PLANNING REPORT

Planning & Zoning Commission

TOWNES AT TUTTLE 24-055INF

Case Summary

Draft Special Area Plan – Southwest Area Plan

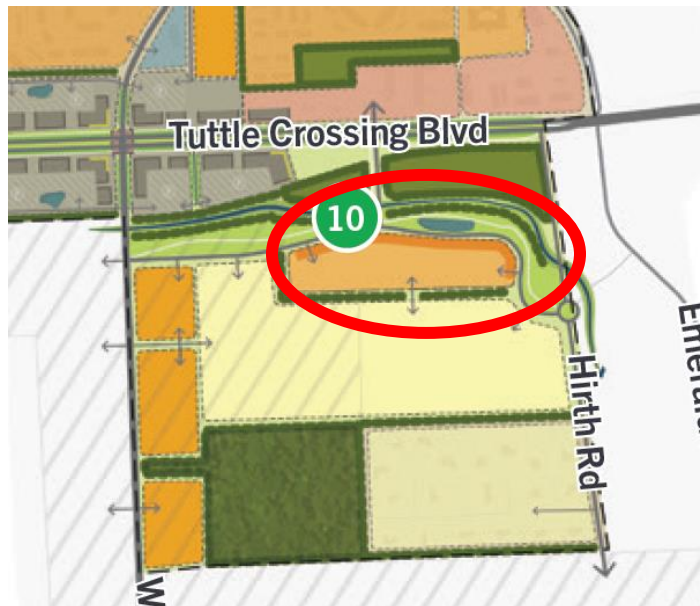
This site is highlighted in red on the adjacent map. Although the Future Land Use designation is Mixed Use -

Neighborhood, more specific recommendations are provided for this site in the area plan. The darker orange tones represent residential with an opportunity for more density. The updated Community Plan provides the following recommendation for the properties southwest of Hirth and Tuttle Crossing:

The Southwest Area Plan provides recommendations regarding site layout and the accommodation of open spaces within the design. The area plan recommends that the tree stand and stream corridor located north of the development should be preserved to the greatest potential by integrating into the neighborhood open spaces as residential development occurs on adjacent land. Currently, the tree stand is located at the rear of the development and is not incorporated into the design of the neighborhood. Planning Staff would recommend that the layout of the site be altered to make these natural features more prominent and integrated with the neighborhood. This could be accommodated by framing the natural features with a public street and/or the front facades of homes.
